SERVICE BULLETIN

Reference number:	SB-07-1473	Issued: 21 April, 2021
Subject:	Active Differential Wiring Loom Inspection	
Model(s):	Vantage 21MY	
Applicable to:	All Dealers	
Distribute to:	After Sales Manager Executive Manager Service Manager Sales Manager	Warranty Staff Technician(s) Parts Staff

Figure 1

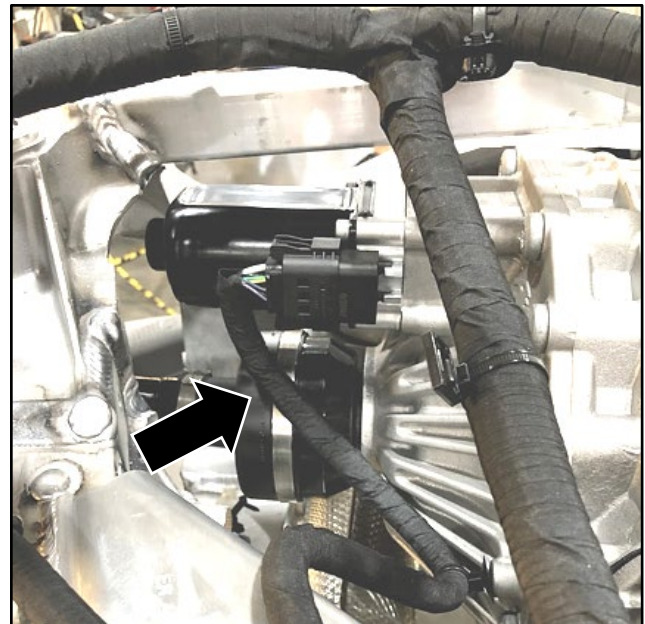
1. Disconnect the battery (refer to Workshop Manual procedure 14.01.CA).
2. Use applicable equipment to lift the vehicle and make it safe.
3. Remove the rear undertray (refer to Workshop Manual procedure 01.02.PB).
4. Do a check for damage to the active-differential wiring loom. Damage can occur where the loom touches the drive shaft (refer to Figure 1).

5. If there is damage to the active-differential wiring loom, you must raise a SpotLight case.

Figure 2

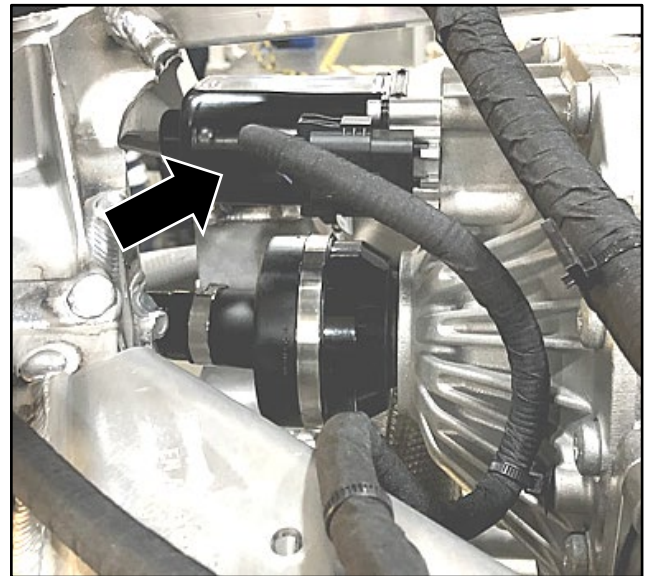
6. Examine the position active-differential wiring loom. The correct position is shown (refer to Figure 2).
If the wiring loom is installed correctly no more steps are necessary.

Figure 3

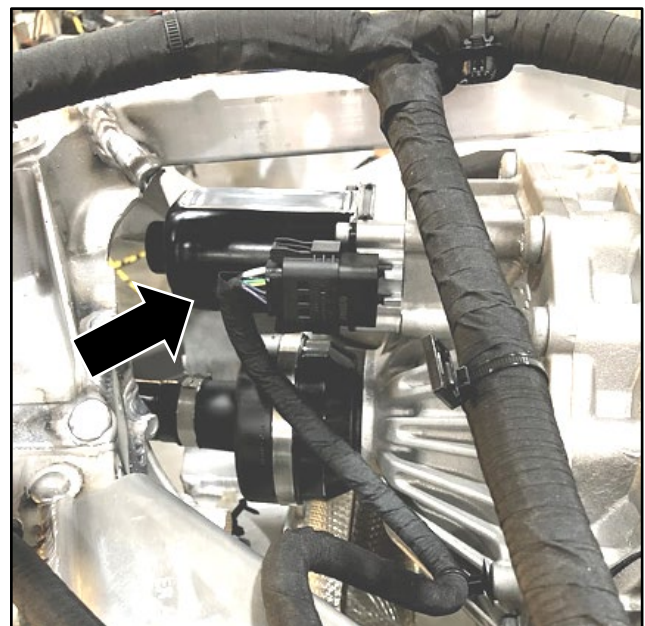
Aston Martin has found that on some Vantage 21MY vehicles with automatic transmission, it is possible for the wiring loom for the active differential to be installed in the incorrect position. This can cause it to rub against the driveshaft.

7. If the active-differential wiring loom is in the position shown (refer to Figure 3), do the actions that follow:
 - Disconnect the wiring loom and rotate it 360 degrees to the correct position (refer to Figure 2).
 - Connect the wiring loom and its fixings.
